STAFF REPORT ACTION REQUIRED

250 Lawrence Avenue West and 219 Glengarry Avenue Official Plan and Zoning By-law Amendment Applications – Request for Direction

Date:	March 17, 2017
To:	North York Community Council
From:	Director, Community Planning, North York District
Wards:	Ward 16 – Eglinton-Lawrence
Reference Number:	15 133424 NNY 16 OZ

Attachment 2: Site Plan

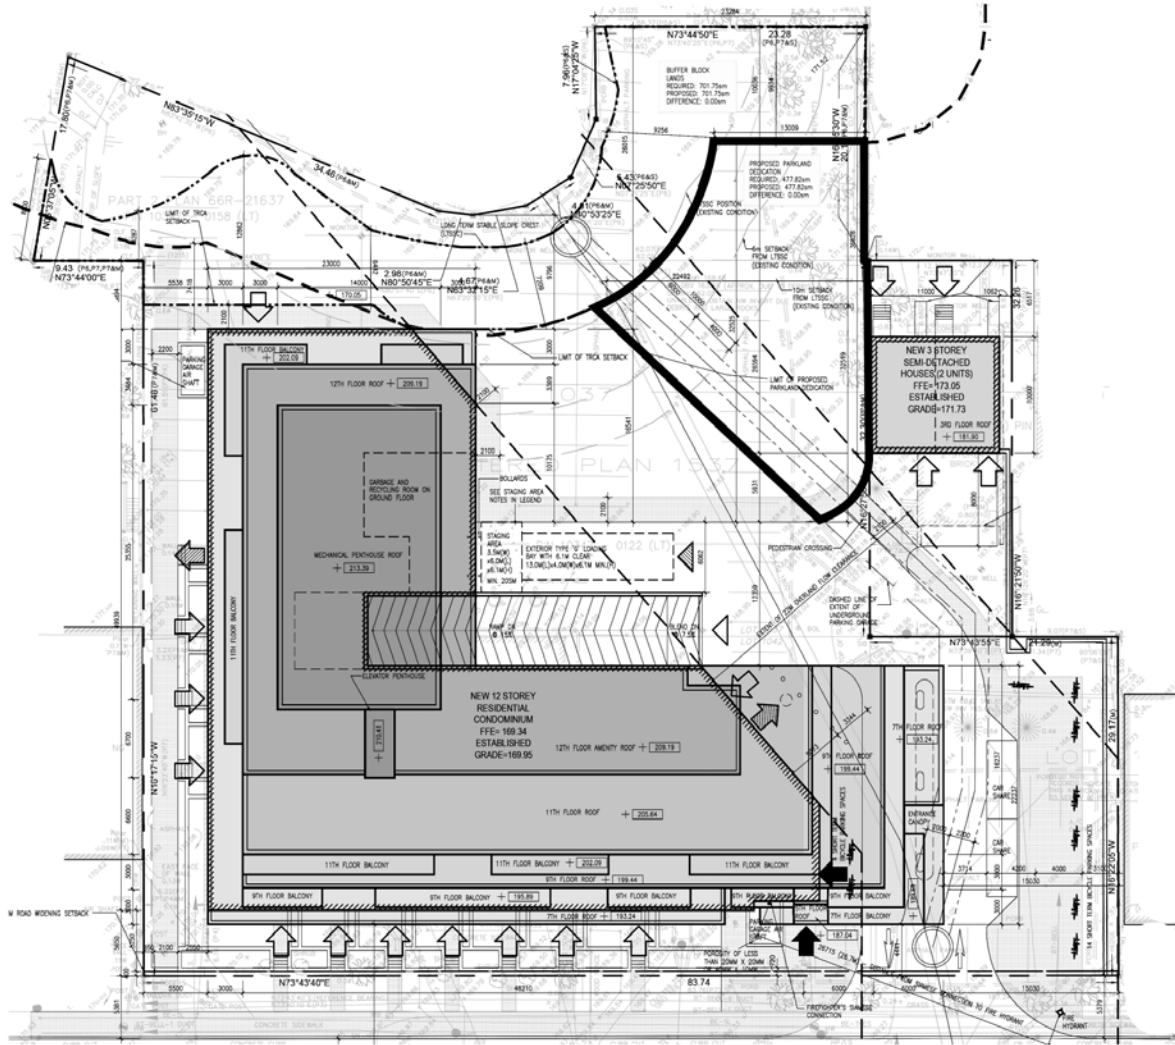
The applicant also proposes a 19 metre wide curb cut at the Lawrence Avenue West vehicular access. The proposed curb cut is excessive and will aggravate pedestrian vehicular conflict along the public street. A revised curb cut length to more typical standards of 6 to 9 metres with a tight radius is recommended by Planning and Transportation Services staff.

The applicant is also proposing a 4.6 metres driveway ingress and egress for vehicles. Staff suggested these should be revised to a standard width of 3 metres and that the two proposed car share parking spaces located on the east side of the site adjacent to the driveway should be relocated to the underground garage to allow for a larger landscape open space.

To ensure privacy for ground floor units and enhancement of the public realm along the Lawrence Avenue West frontage, staff encourage the applicant to provide a minimum 2 metre wide raised landscape planter between the Lawrence Avenue West boulevard and the proposed ground floor unit private patios to act as enclosure in lieu of decorative fencing. Staff also encourage the applicant to provide a minimum 1.5 metre landscape planter between the patios of ground floor units and the walkway along the west property line.

Utilities should also be integrated into the building where possible to improve the safety and attractiveness of the public realm. The large air shaft at the main entry facing Lawrence Avenue West should be relocated into the building face away from the main entrance to allow for a landscape and seating feature at the main entrances to provide pedestrian amenity along the street edge.

Attachment 3: Apartment Building North Elevation

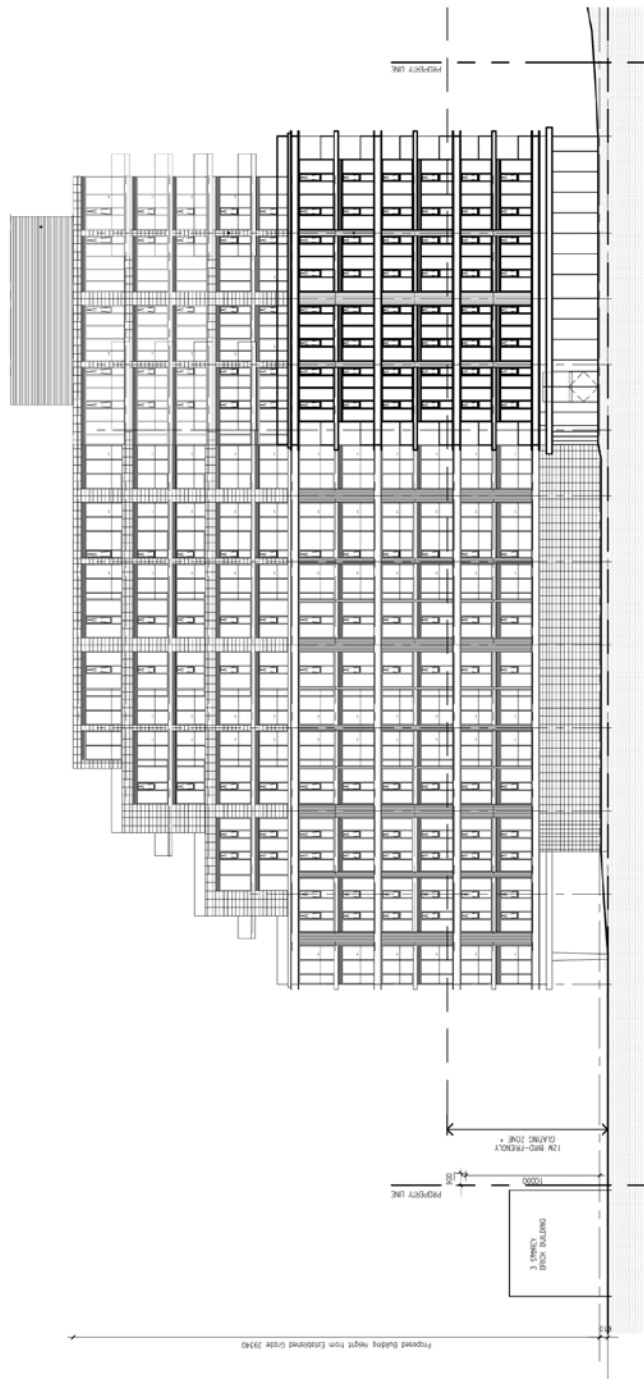
With regards to appropriate transition to the adjacent *Neighbourhoods* designations at the rear of the site, the building should adhere to a rear 45 degree angular plane taken at grade from the westerly boundary of 219 Glengarry Avenue that then rotates in a conical fashion at the south west corner of 219 Glengarry Avenue. The 45 degree angular plane should then continue along the south property line of both 219 and 217 Glengarry Avenue with an additional conical rotation at the south west corner of 215 Glengarry Avenue. Building adherence to the 45 degree angular planes at the adjacent *Neighbourhoods* designated properties creates a stepping down of height in scale to the lower 2-storey buildings in the *Neighbourhoods* designation, respecting the scale of the residential properties as well as would aid in limiting shadow impact on the adjacent *Neighbourhoods* properties to the east.

Revised massing is required to reduce shadow impact on the *Neighborhoods* to the east of the proposal. Staff also recommend revision of building massing and reduction of height along the rear deep portion of the building to address shadows on the on-site park dedication in the afternoon.

Attachment 5: Apartment Building East Elevation

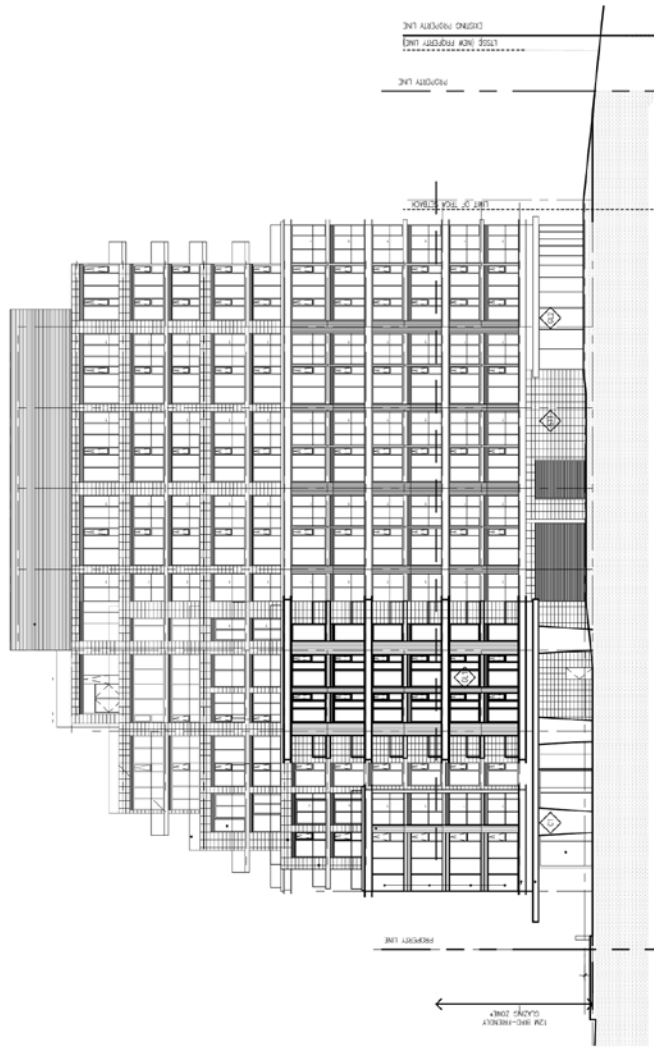
The proposal should conform to a 45 degree angular plane taken from the entire east property line of the adjacent 2-storey residential home at 232 Lawrence Avenue West. This will result in a built form on Lawrence Avenue West that steps down to the easterly portion of the site, providing transition to the adjacent lower 2-storey housing in the *Neighbourhoods* designation.

By not exceeding the 1:1 scale with Lawrence Avenue West and correctly demonstrating the proper transition to *Neighbourhoods* to the east and northeast, provided through appropriate 45 degree angular planes, the proposed building will have less shadow impact on the adjacent *Neighbourhoods* to the east and northeast and would better fit within the existing and planned context of Lawrence Avenue West. Revision to the building massing and height would also reduce the overall density proposed on site of 3.6 times the area of the lot.
